Nepean River Pump and Pipeline (SSD_5225) Response to exhibition of Environmental Impact Statement

Nepean River Pump and Pipeline (SSD_5225) Response to exhibition of EIS Additional comments by NSW Office of Water

Nepean River Pump and Pipeline (SSD_5225) Response to exhibition of EIS IQQM Modelling by NSW Office of Water

Table A1 – Impact of annual entitlement on filling period- Time to fill

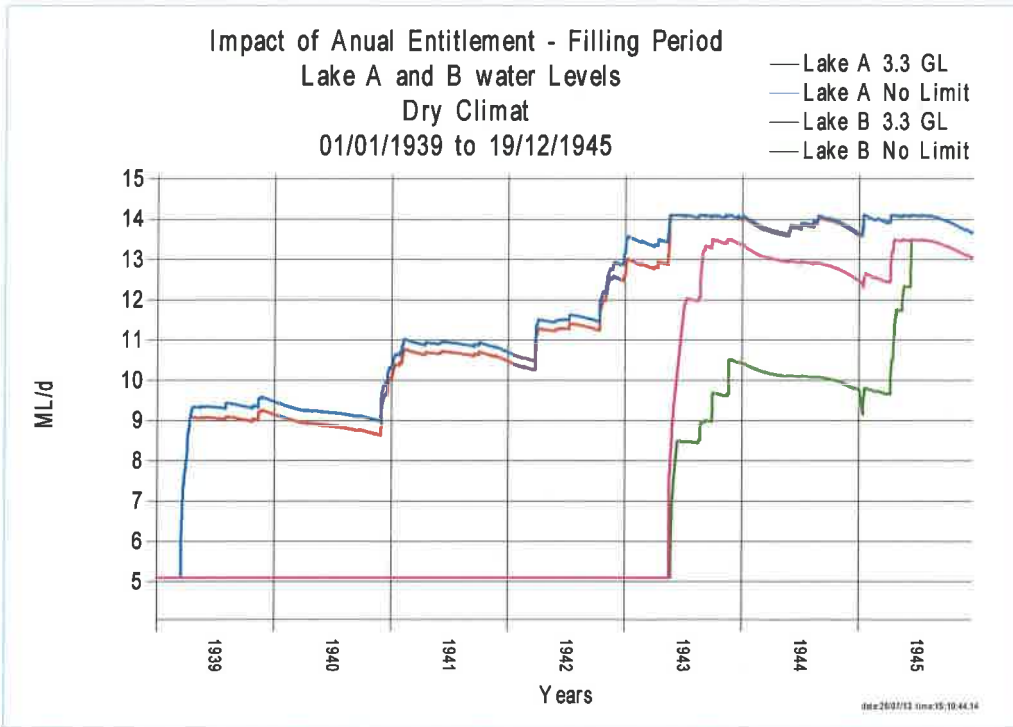
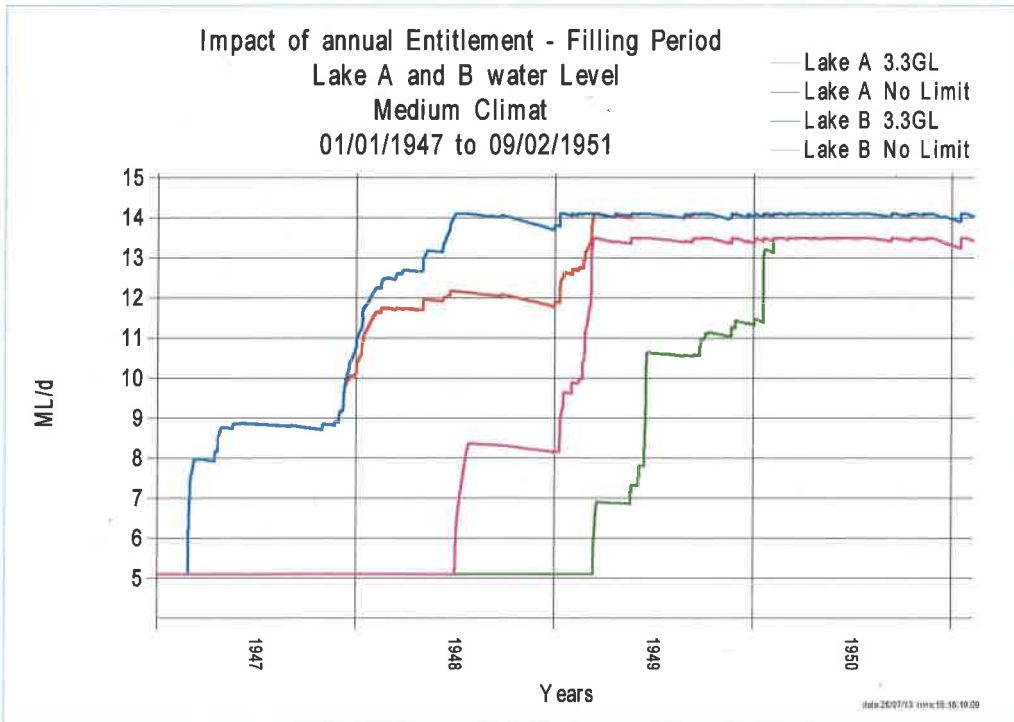
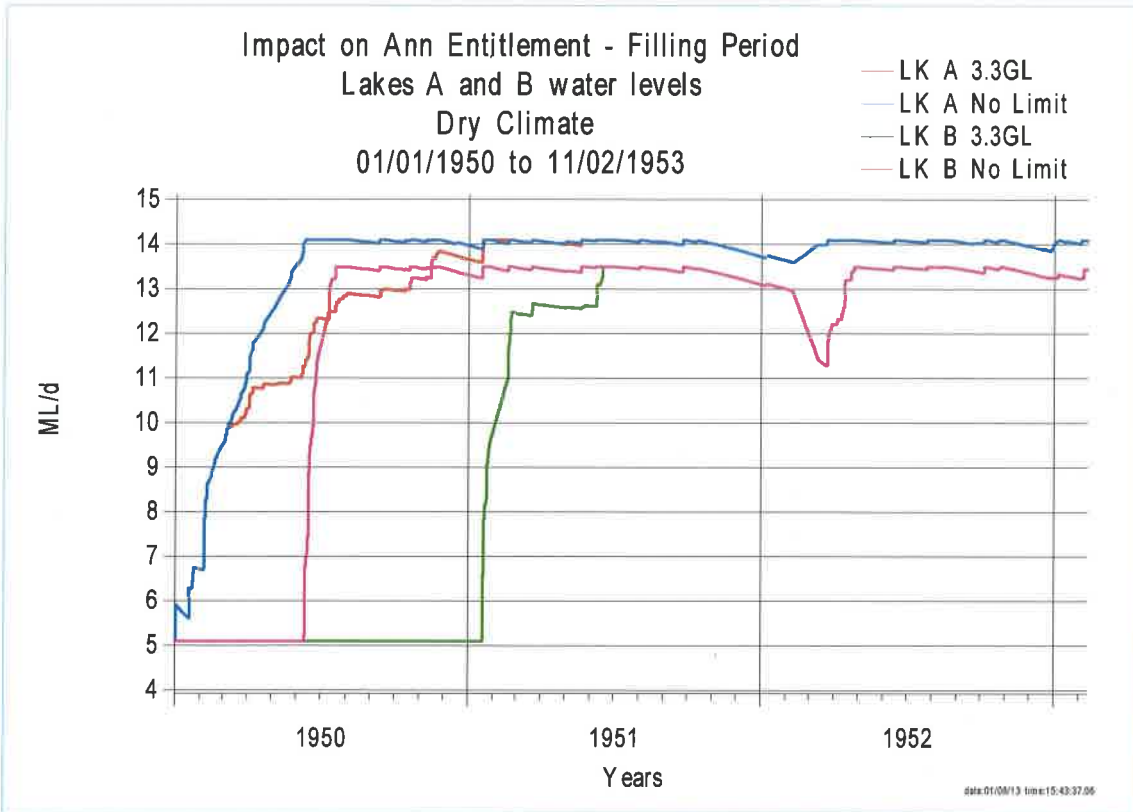
Appendix E Water Balance Report, p.28 Table 5-1 Time to fill	The attached IQQM model result report (Attachment B, Table A1) shows the impact of annual entitlement (3.3GL) on lake filling period.	The Water Balance report does not address the impact of the annual entitlement (extraction limit) of 3.3 GL per year.

Table A1 and Figures A1-01 to A1-03 shows the impact of 3.3 GL annual entitlement on filling period.

Figure A2-01. Impact of annual entitlement on long term maintenance period.

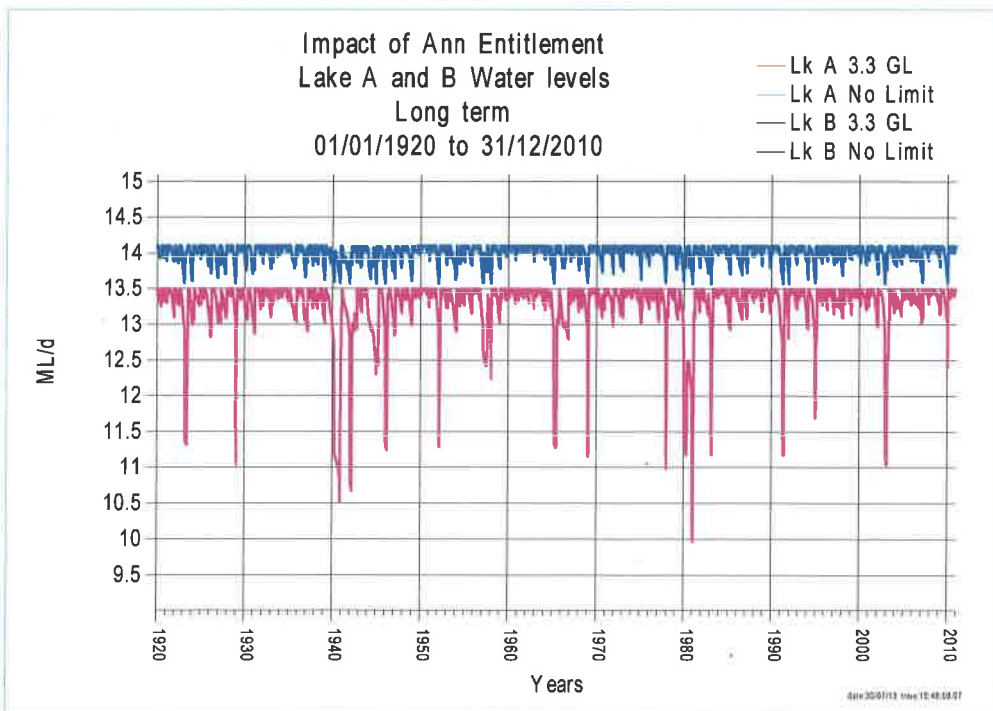
Figure A2-01 shows no impact of annual entitlement on lakes water levels in long term maintenance period.

Figure C-01 Comparing Three scenarios Lake A water level

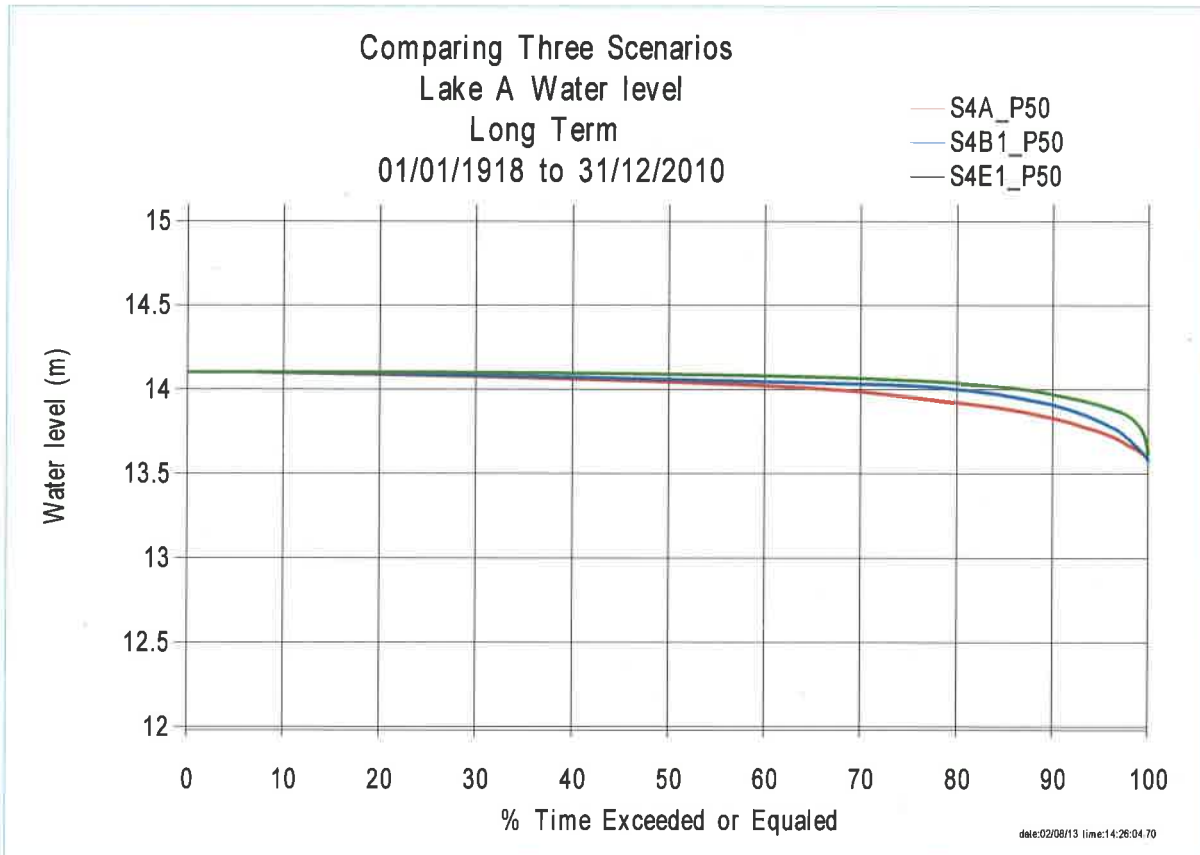
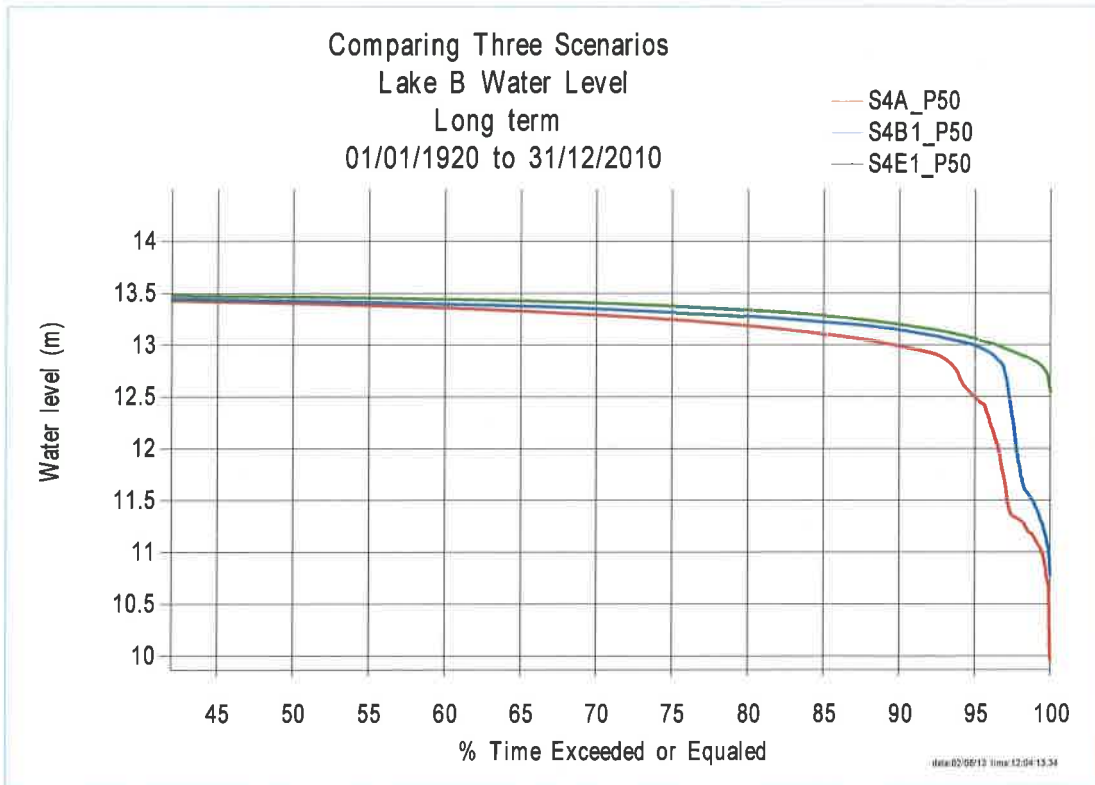
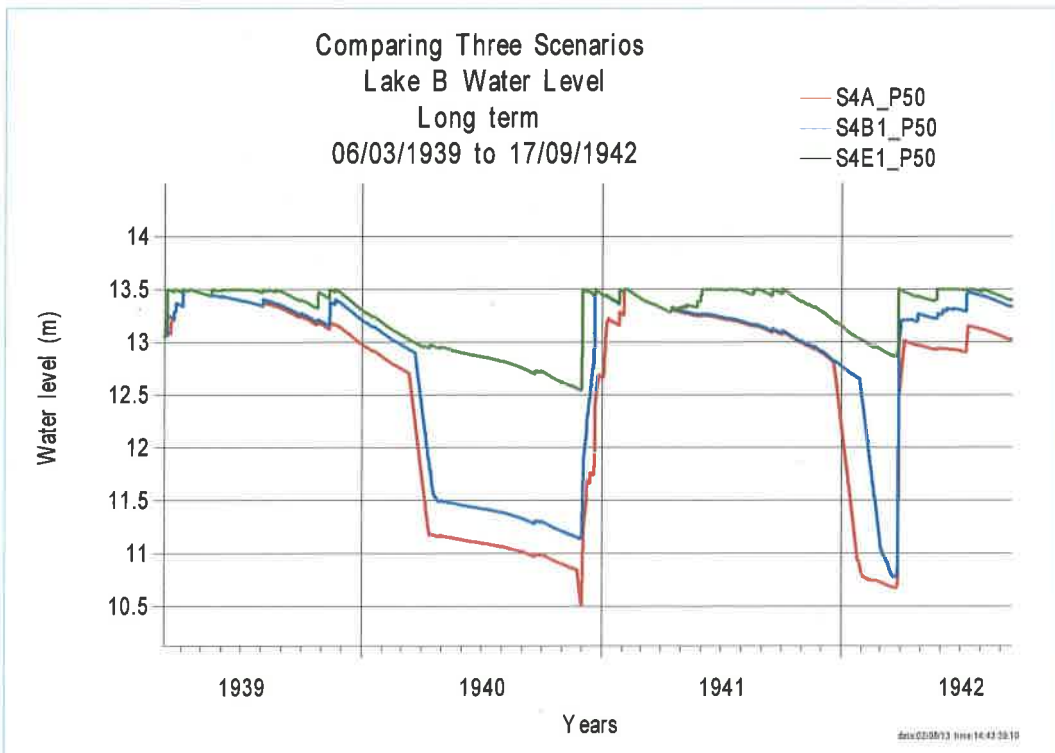
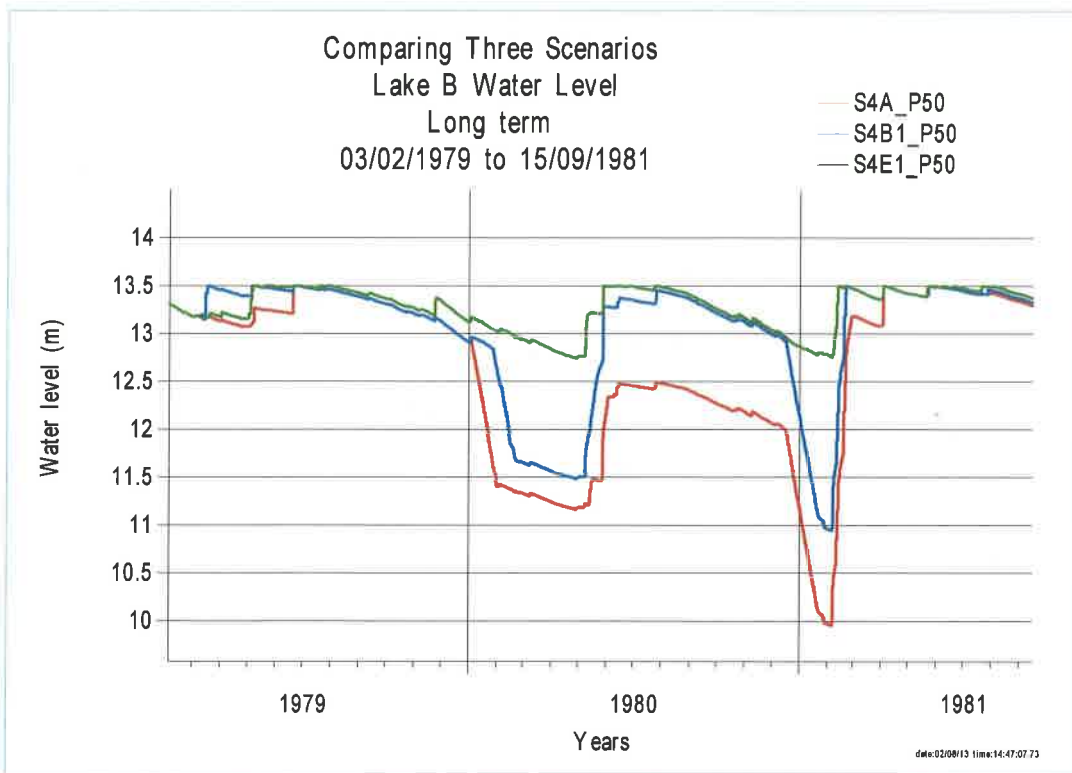
Study the variation water level in Lakes A and B under long term climatic variability and above pumping conditions from Lake B to A. Figure C-01 and C-02 shows the water level in Lake A and B for all three scenarios are within -0.5 m 90% of the time. Figures C-03 and C-04 show Lake B water level is below 0.5 m for more than a year for some scenarios.

Figure C2-01A Lake A water level with different pumping rates

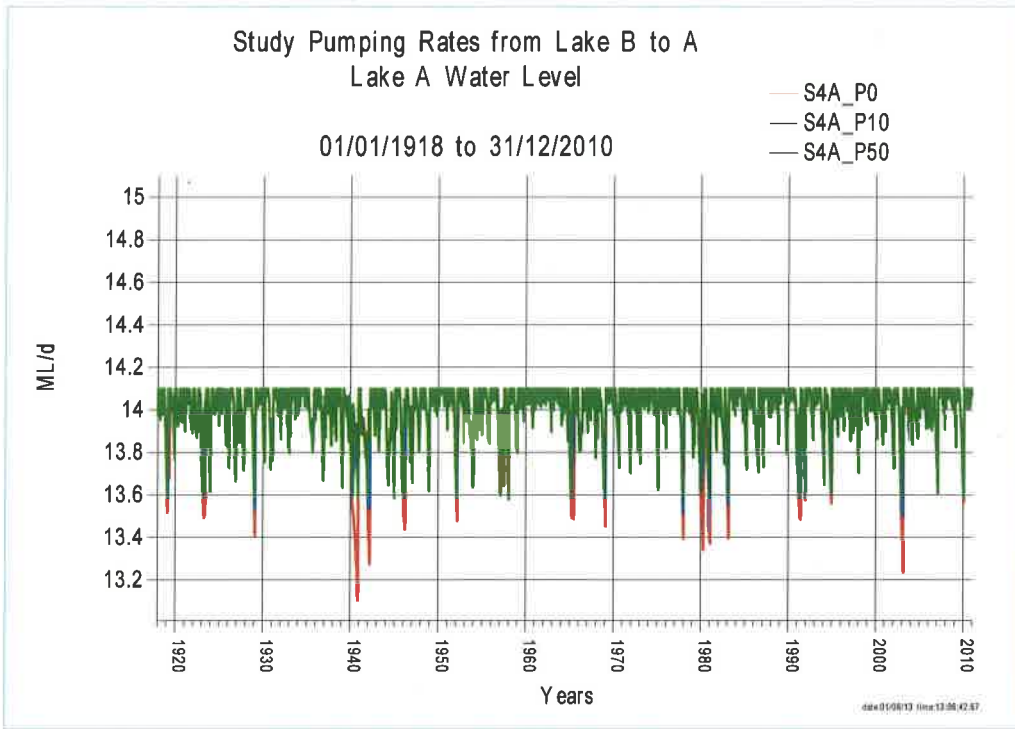
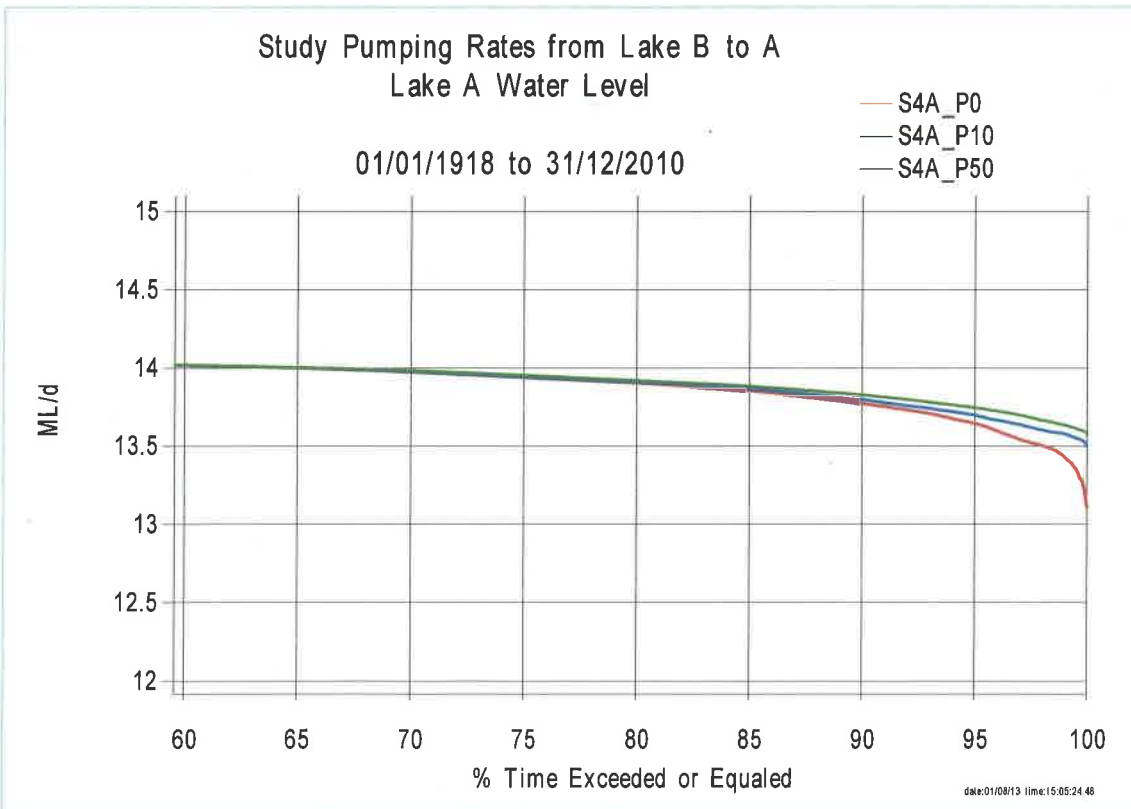
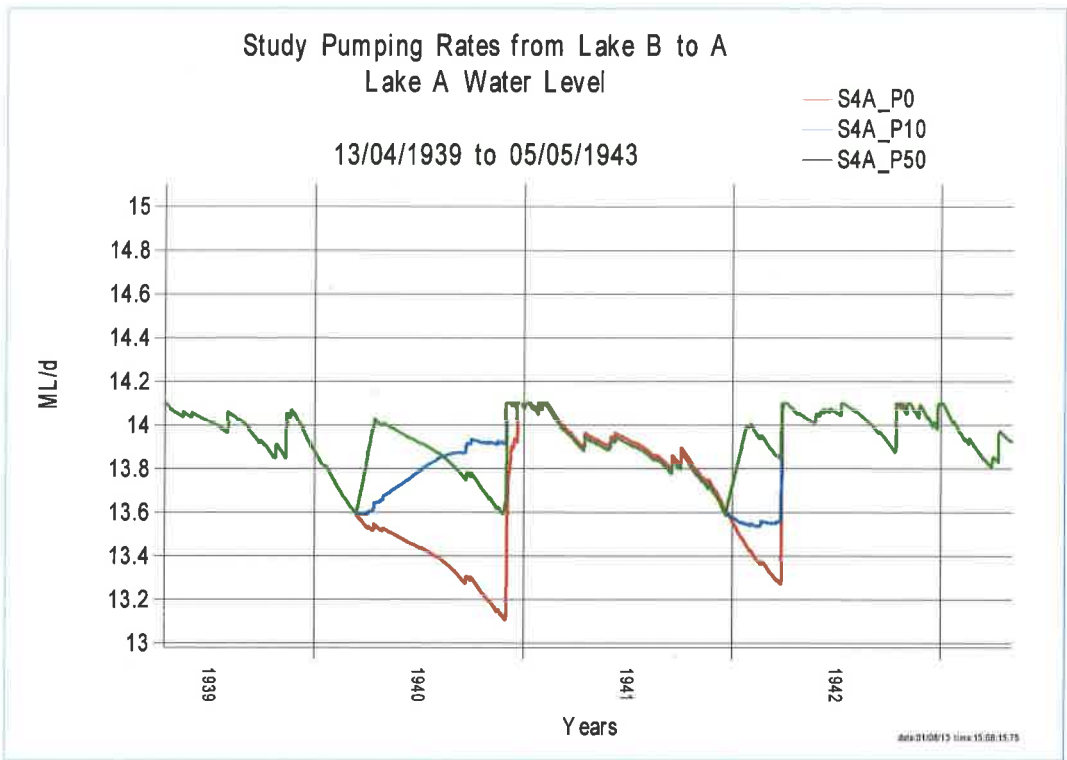
Figures C2-01A and C2-01B show that Lake A water level is within 0.5 m even with no pumping from Lake B to A. for 90% of the time, but analysing individual events in Figure C2-01C shows no pumping conditions Lake A water level could be below 0.5 m for long period.
